**Plan for Site Characterization in Support of Decommissioning
of the Molycorp Inc. Washington, Pa Facility**

**Submitted to the U. S. Nuclear Regulatory Commission,
Division of Low Level Waste Management and Decommissioning
Revised and Resubmitted, August, 1993**

| NRC Comments on Molycorp's First Draft of the Site Characterization Plan, and Molycorp's Response | H-1 |

Figure 5-2: Areas at the Molycorp, Washington Pa Plant Site Currently Classified as Affected Areas

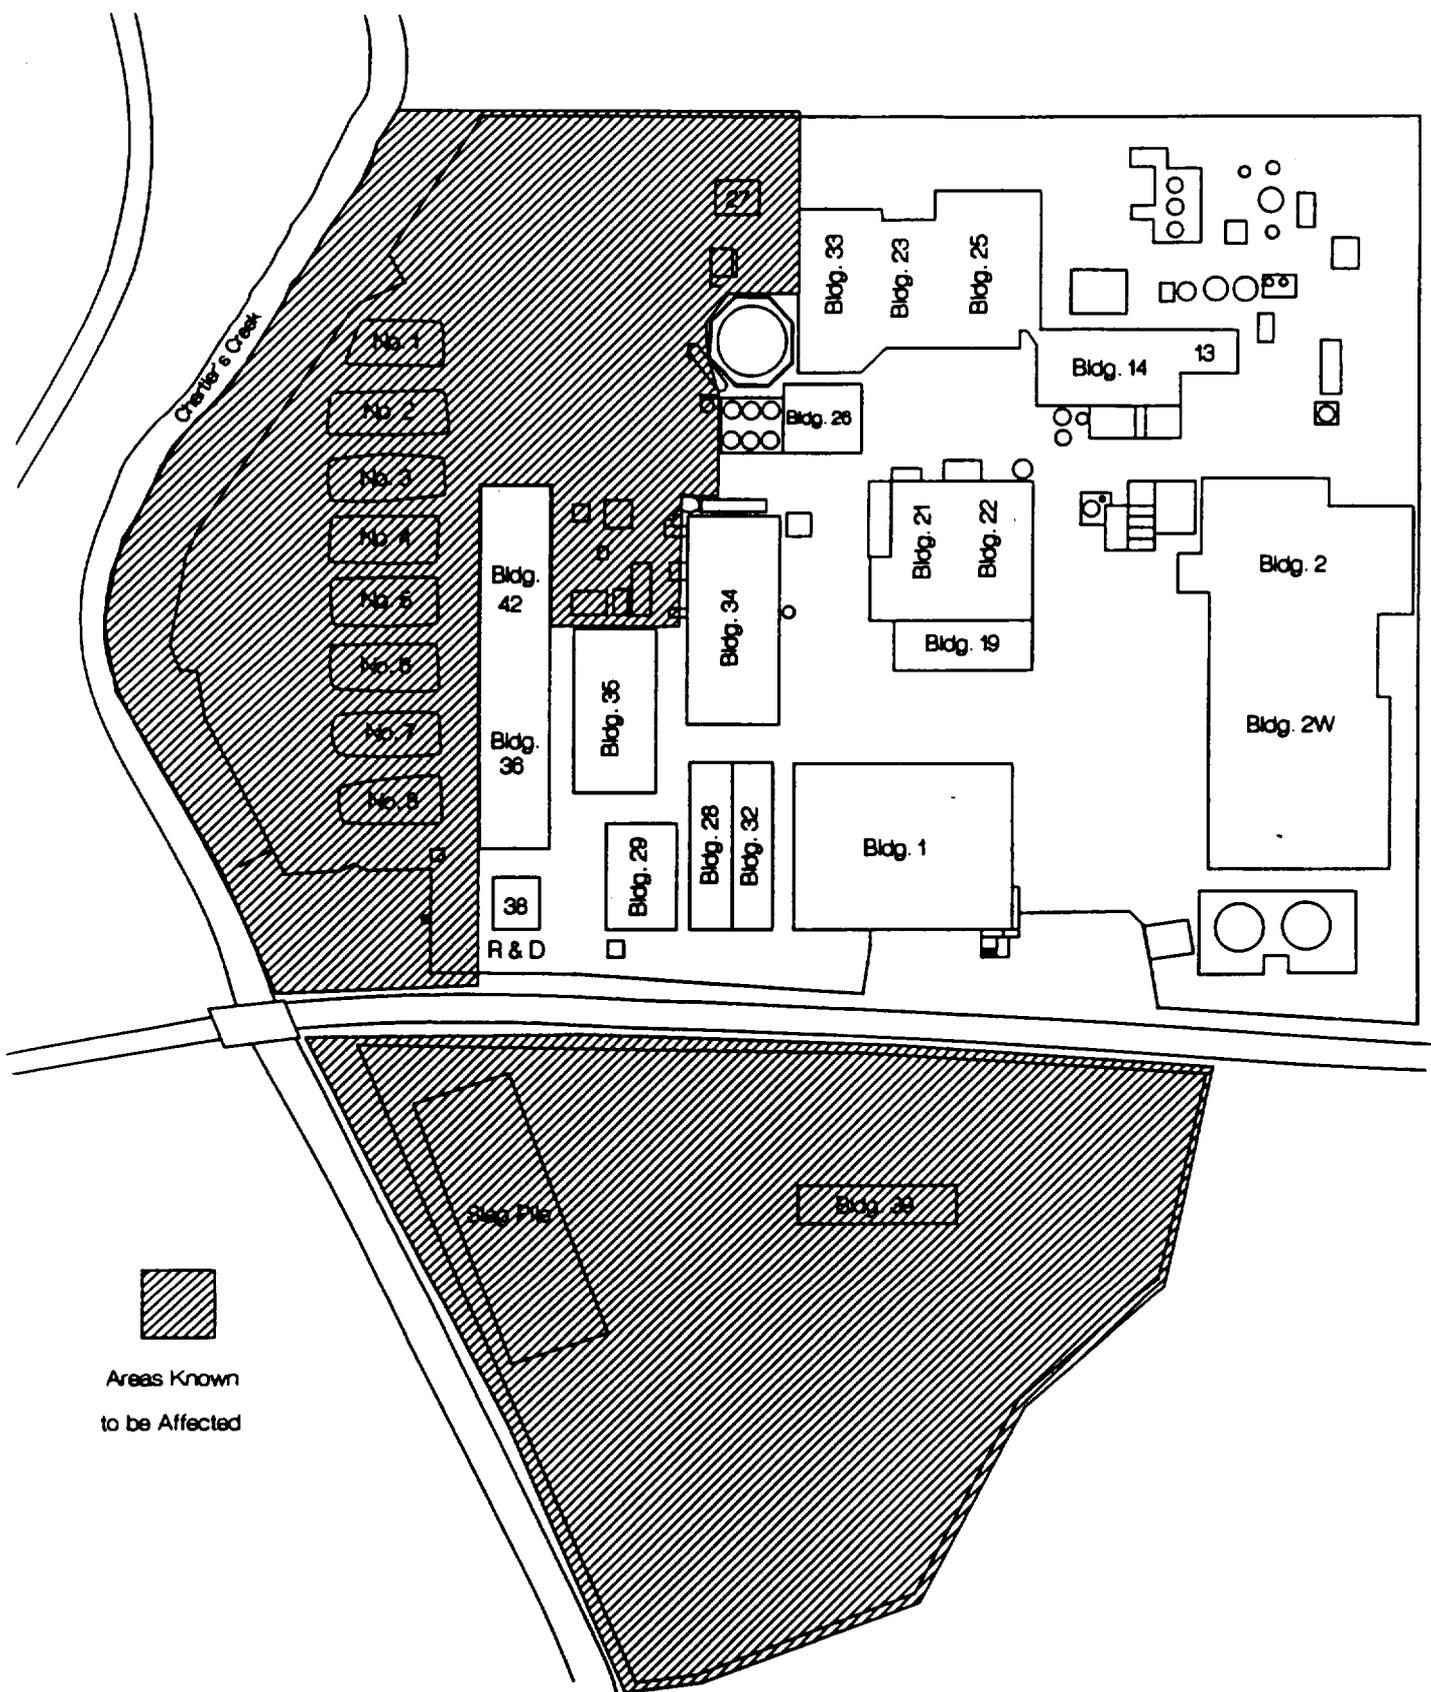
Also, historical information on source material processing and radiological surveys at this site suggest that the boundary of the affected area outlined in Figure 5-2 should be extended in the "active plant area" north of Caldwell Avenue. The discussion in the SCP relating to this Figure supports this position. The SCP states (Section 5.2, page 37) that "due to the historical usage patterns, there is a potential for contamination under or adjacent to the R & D offices and the process buildings west of Building 34, where the FeCb slag was produced". ORAU's previous survey of the site also identified elevated radiation levels under and adjacent to Building 34 and adjacent to Buildings 20, 25, 26, 28, 29 (R & D Bldg.), 30 and the Bag House east of Building 20. Also, based on a 1971 AHP report, Building 33 was a former radioactive material storage area for FeCb ore. According to the guidance provided in NUREG/CR-5849, affected areas are defined as areas that have potential radioactive contamination (based on plant history) or known radioactive contamination (based on surveys). Therefore, the areas described above, currently outside of the affected area shown in Figure 5-2, should be included as affected areas unless Molycorp can demonstrate that these areas are unaffected (i.e., no radioactive material above background concentrations). The SCP should also identify any affected areas outside the site boundary resulting from past operations at this facility. For example, areas adjacent to Chartiers Creek and outside the facility fenceline, that are either known or suspected to be contaminated, should be included as an affected area.

- (6) **Surface/Subsurface Contamination and Affected/Unaffected Areas:** The NRC comment says that "Surface gamma exposure rates should not be used as the sole indicator of potential subsurface contamination in determining 'affected' and 'unaffected' areas. The SCP indicates (Section 5.2.1, pp. 36-38) that surface gamma exposure data, below background levels, are indicative of uncontaminated subsurface soils and may be useful in dividing the site into affected and unaffected areas." The NRC also suggests that "the boundary of the affected area outlined in Figure 5-2 should be extended in the 'active plant area' north of Caldwell

Figure 5.2 in the SCP is only meant to show areas that are currently classified as affected areas, based on past site characterization work. The status of other areas in the plant is not presently known because in-depth characterization work has not been completed there. These areas will be completely surveyed for both surface and, where historical operations indicate there is any possibility of past burial of material, for subsurface radiological contamination, as part of the site characterization study. Final classification of all potentially affected areas will be provided in the site characterization report, which will be submitted to the NRC after the site characterization study is completed.

Because the status of the areas not shown as affected in Figure 5.2 of the SCP is presently not known, we are unwilling to classify them as affected. The site characterization study will determine what portion of these areas are unaffected. In particular, the soil underneath buildings that were constructed before the processing of FeCb ore began can be assumed to be unaffected. Also, areas that have been under pavement

prior to and during the processing of FeCb are unaffected. For the purposes of the SCP, we will divide the site into areas that are known to be affected, and areas whose status is unknown. Under this classification system, Figure 5.2 will be unaltered. In the SCP, we made several ambiguous statements which suggested that areas not shown as affected in Figure 5.2 are thought to be unaffected. These statements are unwarranted and have been deleted from the SCP.
